**Technical Service
BULLETIN**

**UNINTENDED POWER REAR WINDOW
ACTIVATION**

'99 – '01 4Runner

**ELECTRICAL
EL005-01**

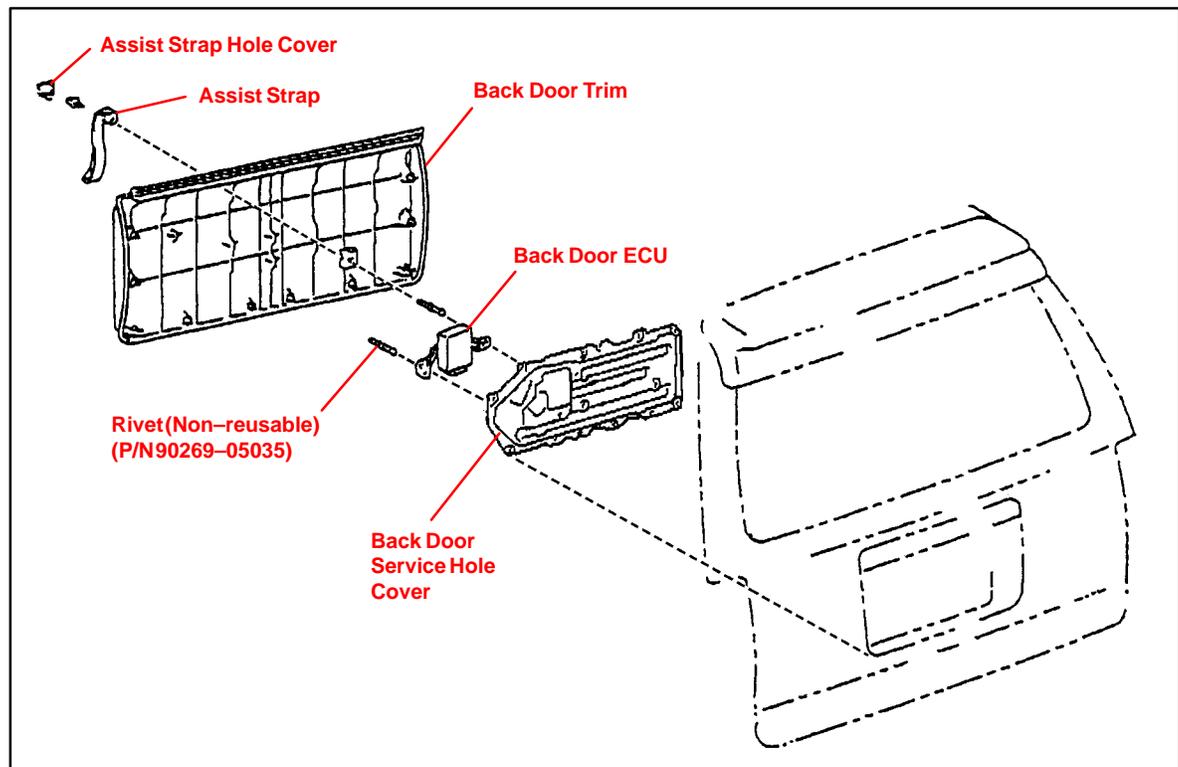
Repair
Procedure #1**Replace the Relay Assembly, Power Window, No. 1 (Back Door ECU).**

- A. Remove the Back Door Trim Panel.
 - a. Remove the assist strap hole cover and unbolt the assist strap.
 - b. Using a trim tool, remove the back door trim panel (see illustration below).

- If dedicated trim removal tools are not available, wrap a flat screwdriver with masking tape to protect the rear door paint from damage.
- The back door trim clips have sealing gaskets. Make sure not to lose them when removing the trim panel.

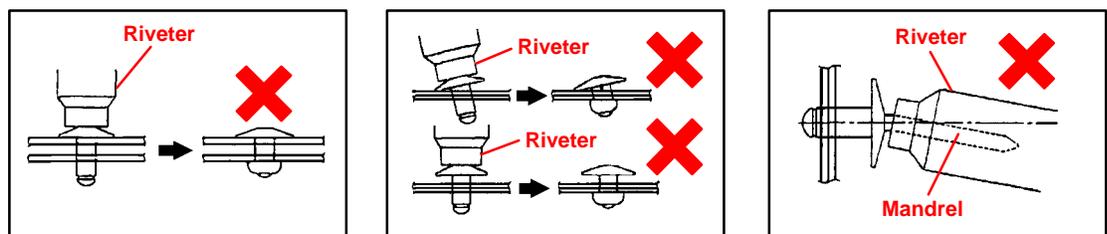
- B. Remove the Back Door ECU.
 - a. Disconnect the ECU to harness connector.
 - b. Remove the Back Door Service Hole Cover. Take care not to damage the 3 white plastic retention clips.
 - c. Place the panel (ECU side up) over a slightly open vice (open 1/2" at maximum), so that the outer portion of the rivet hole area is supported by the vice.
 - d. Using a 3.5 mm drill bit, drill out the rivet heads.

Ensure that the drill bit is as close to perpendicular as possible to prevent damage to the edge of the rivet holes during the drilling process.

- C. Remove the Back Door ECU.
- D. Install the new Back Door ECU.
 - Re-secure the new ECU with 2 new Rivets (P/N 90269–05035).

To ensure proper water intrusion protection, make sure that the rivet is properly inserted into the securing hole before affixing it. Refer to the warning illustrations below.
